TRUSWELL
DUPLEXES
GRADING AND
DRAINAGE PLAN

Rio Grande
Engineering
1608 CENTRAL AVENUE
SUITE 201
ALBUQUERQUE, NM 87106
(505) 872-0999

RECEIVED
FEB 27 2009
HYDROLOGY

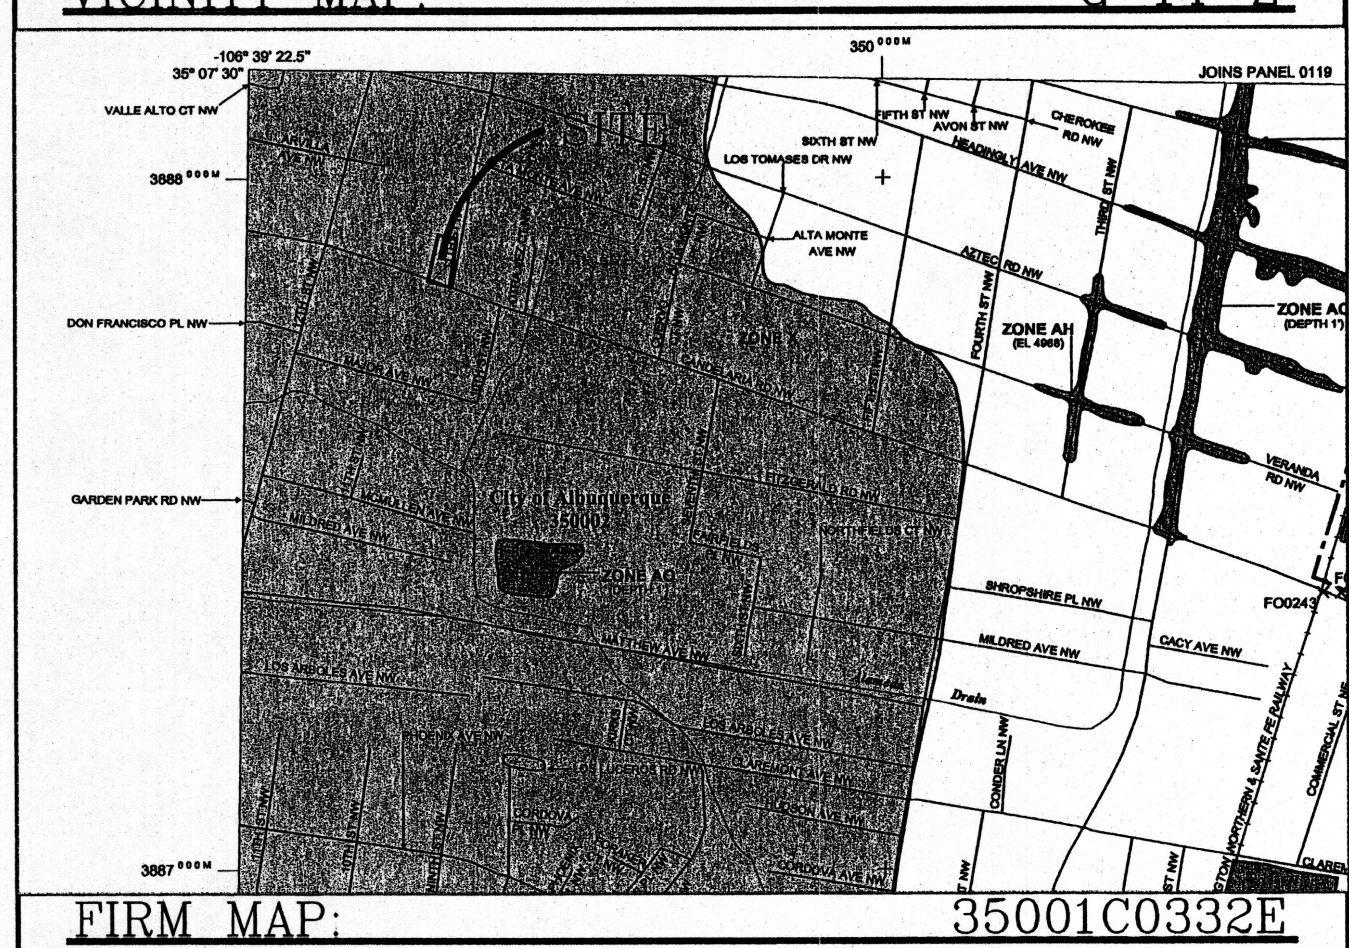
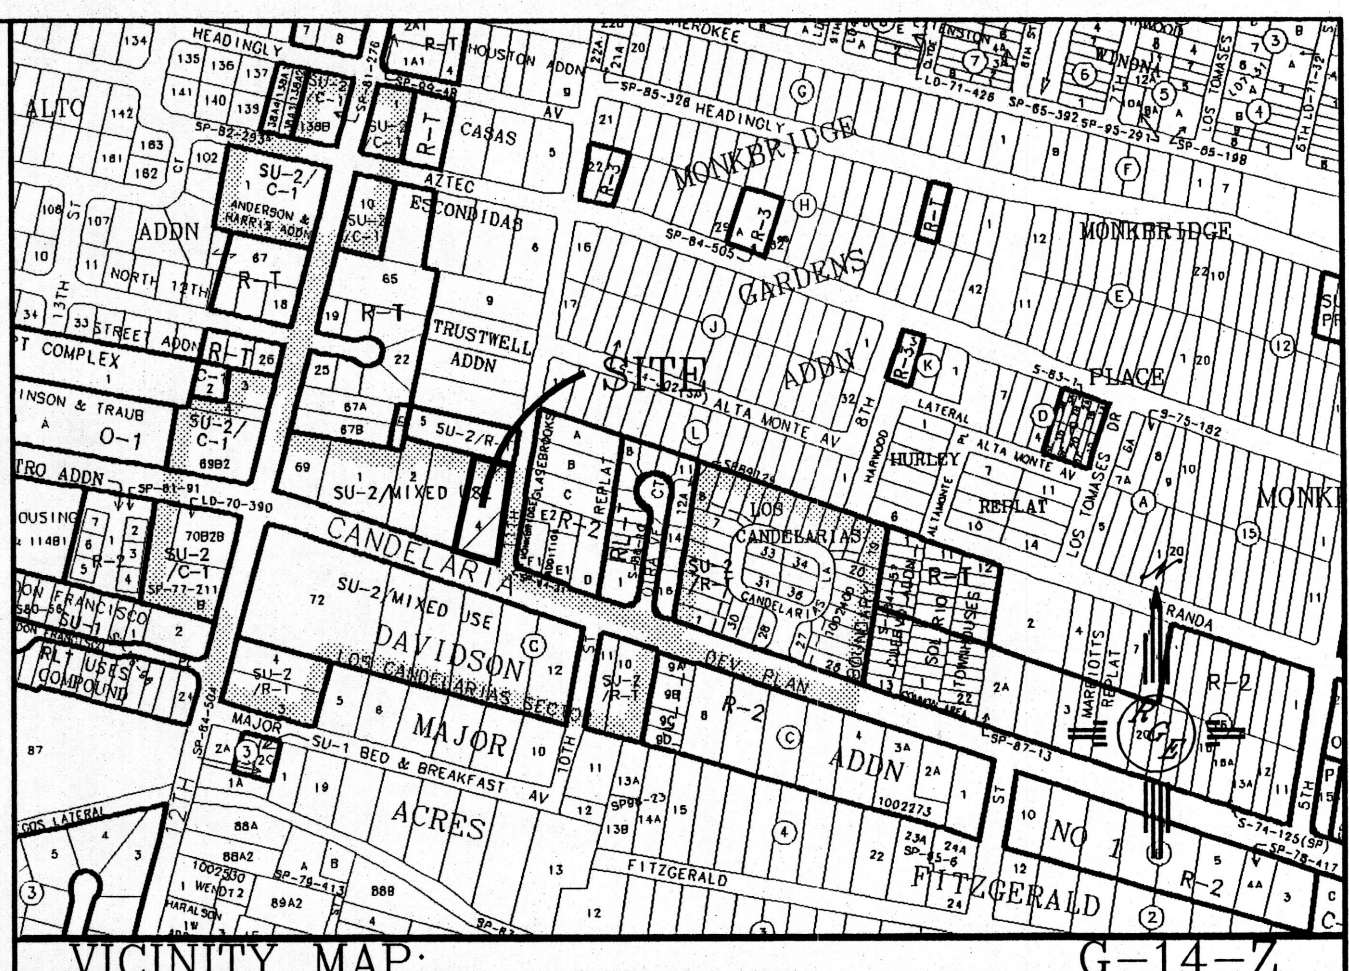
put
cols on plan
check flow?
narrative
Survey benchmark & survey mds
